Prepared by: DATA SUMMARY:	Amy Wolfson, City Planner
Application Number:	22BLD-409
Subject:	Replace Windows and a door on a Priority 2 Rated Building in the City's 1872 Historic Townsite.
Location/APN:	150 South Auburn Street/008-372-005
Applicant/Owners:	Tobin Daugherty/Ken Cutler & Mai Nguyen
Zoning/General Plan:	Town Core/Commercial
Entitlement:	Building Permit
Environmental Status:	Categorical Exemption

The Historic Commission reviewed the proposal at their regular meeting held on December 12, 2023. The commission recommended that the applicant move forward with an archedwindow proposal (Option B) as opposed to a rectangular schematic (Option A) originally proposed. Both options are displayed in the exhibit.

OPTION B - recommended by Historical Commission

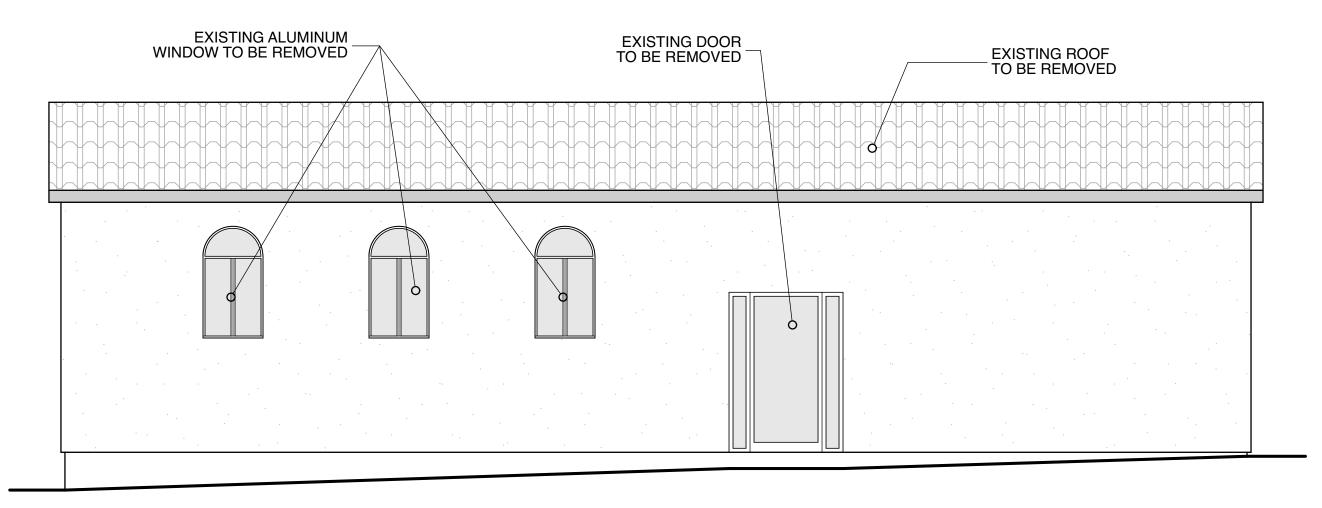
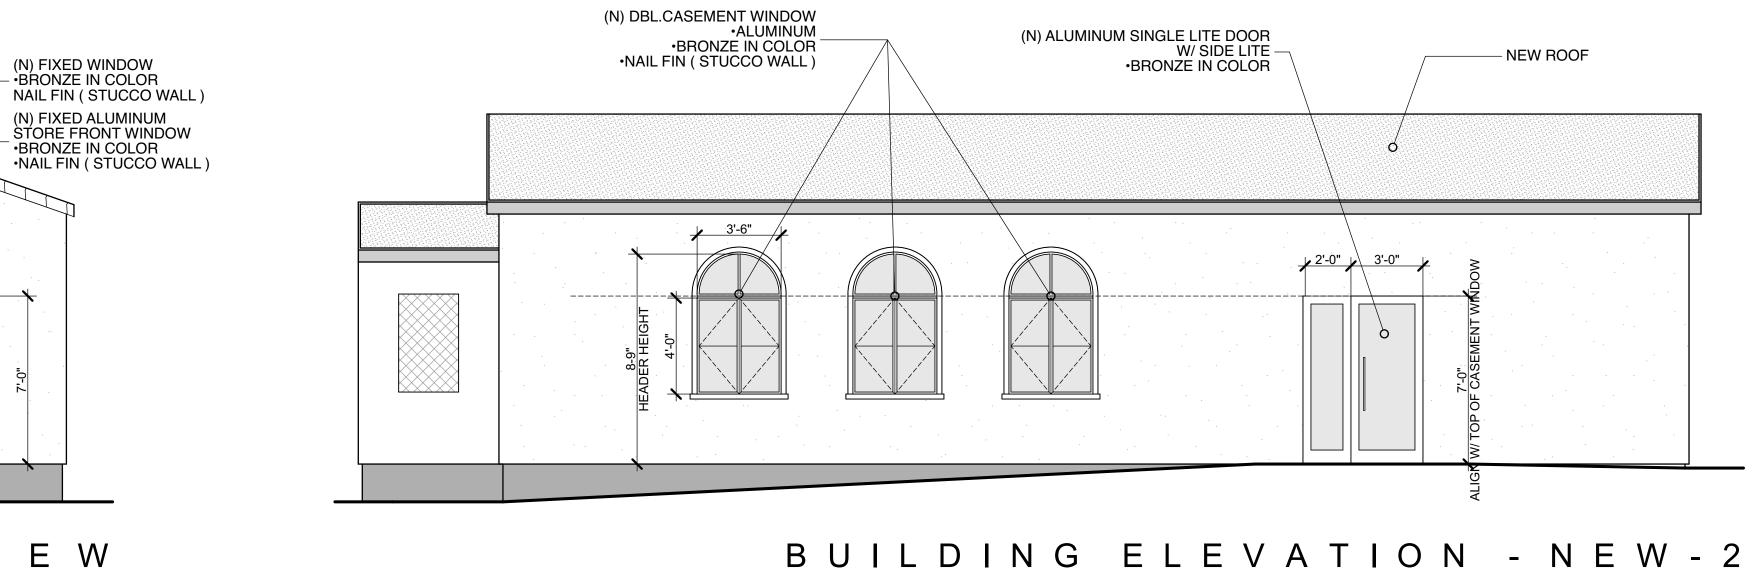
The applicant is requesting to replace the existing aluminum arched windows located on the north side of the building, with larger arched aluminum windows as recommended by the Historic Commission, as shown in the exhibit.

- 1. Determine the project Categorically Exempt as the appropriate level of environmental review in accordance with the California Environmental Quality Act (CEQA) and Guidelines;
- 2. Adoption of Findings of Fact for approval of the window replacement as presented in the Staff Report; and,
- 3. Approval of the project, option B with arched windows, in accordance with the Conditions of Approval as presented in the Staff Report.
